ARDREY CHASE

ENGINEERING
PCO / DETENTION / DRAINAGE PLAN

Revision
APPROVED FOR CONSTRUCTION
CHARLOTTE-MECKLENBURG PLANNING DEPARTMENT
By: Joshua Weaver 2-20-2014

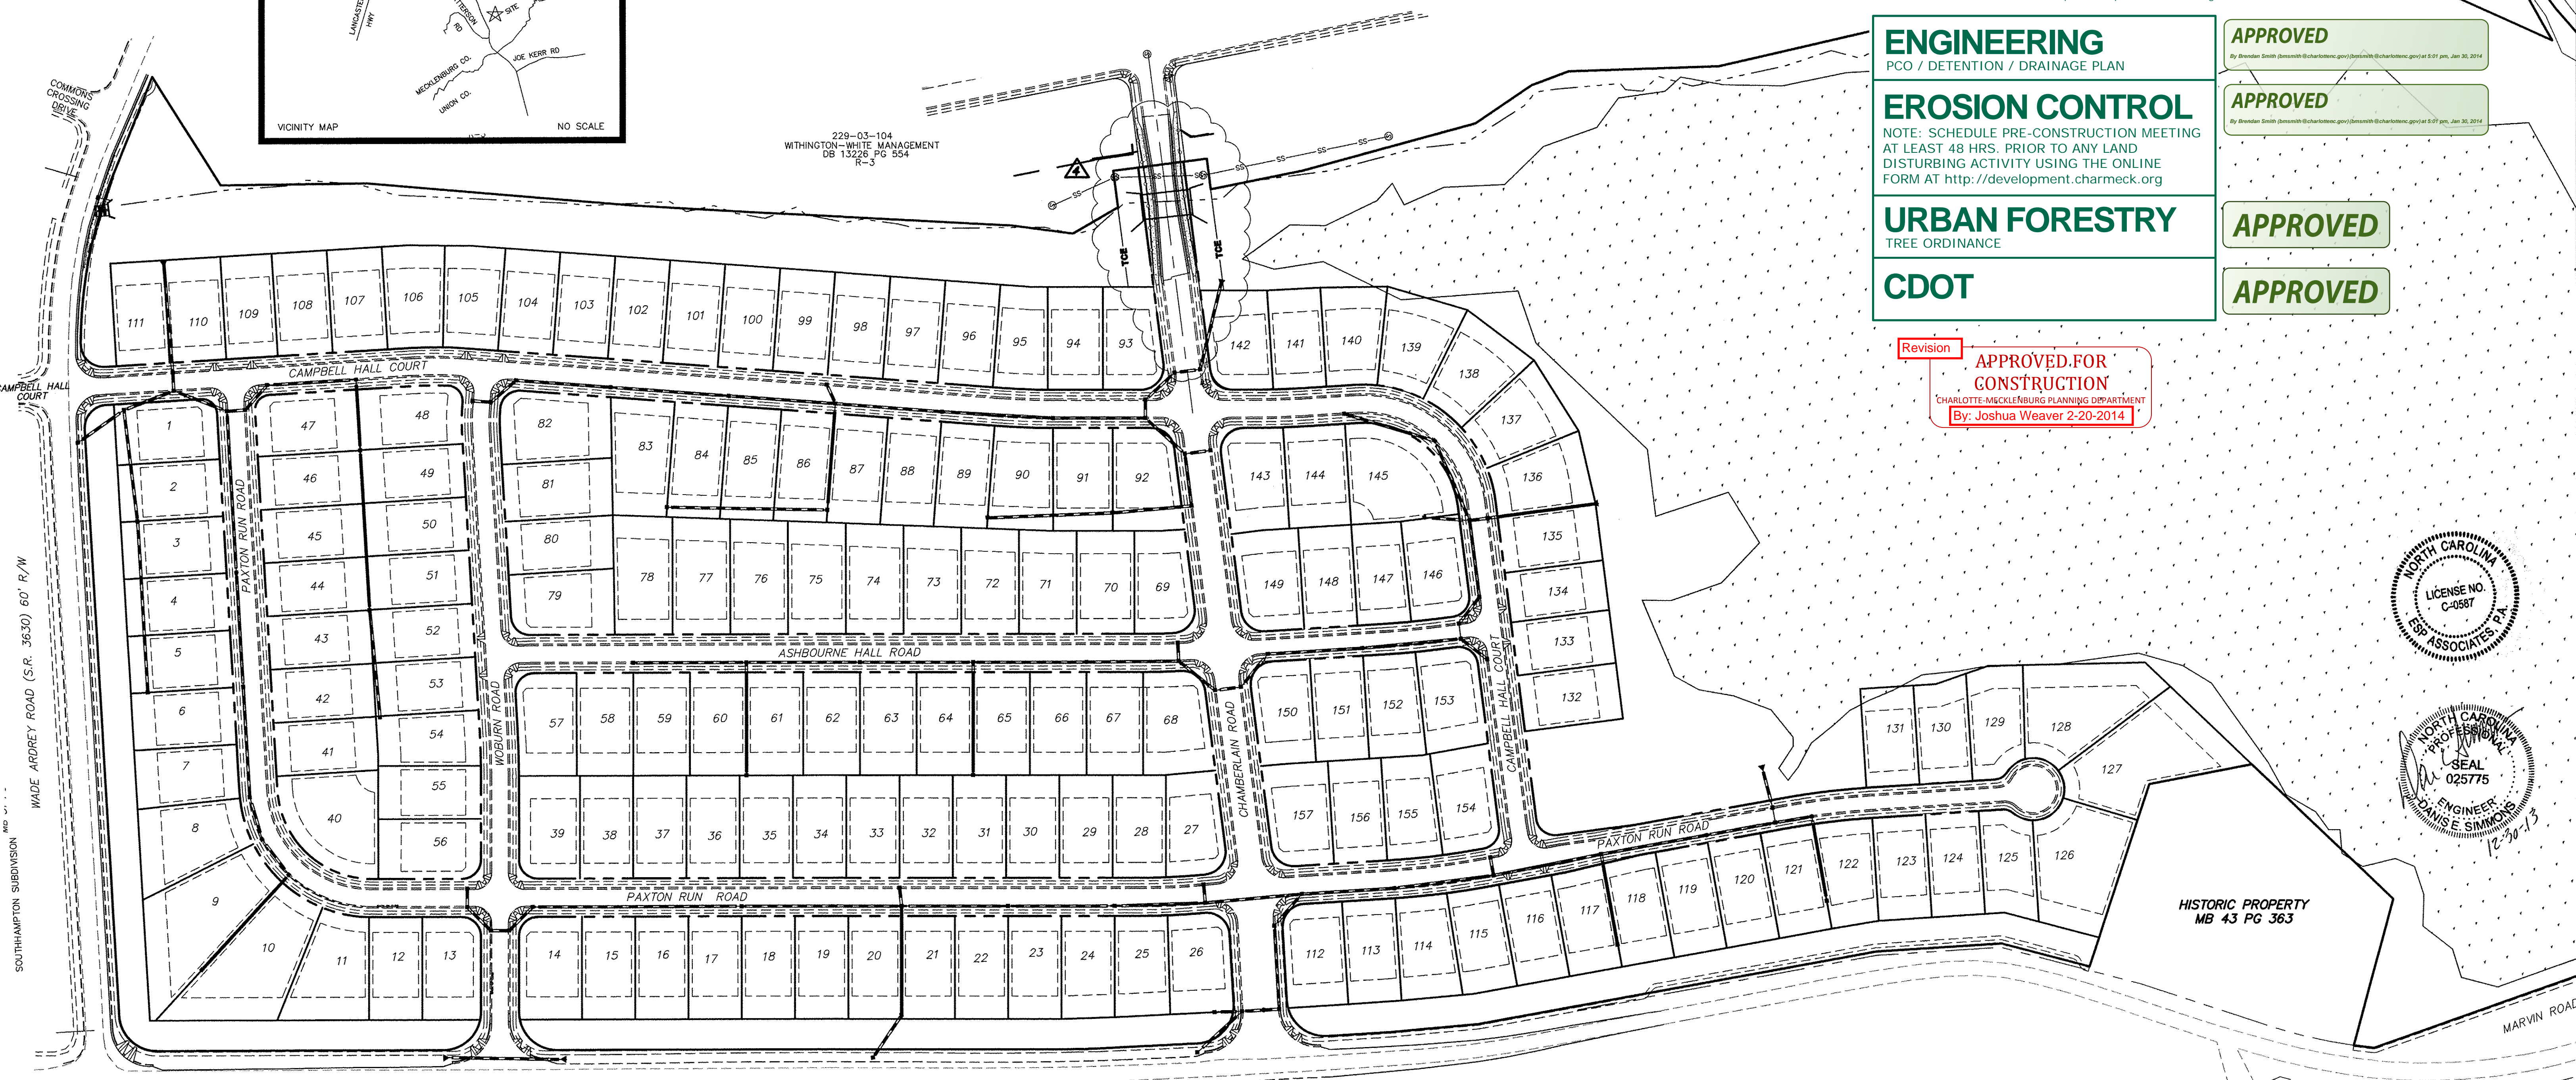
Need detailed PE sealed sheet pile retaining wall drawings prior to construction; also need PE sealed shop drawings for Conspan prior to installation
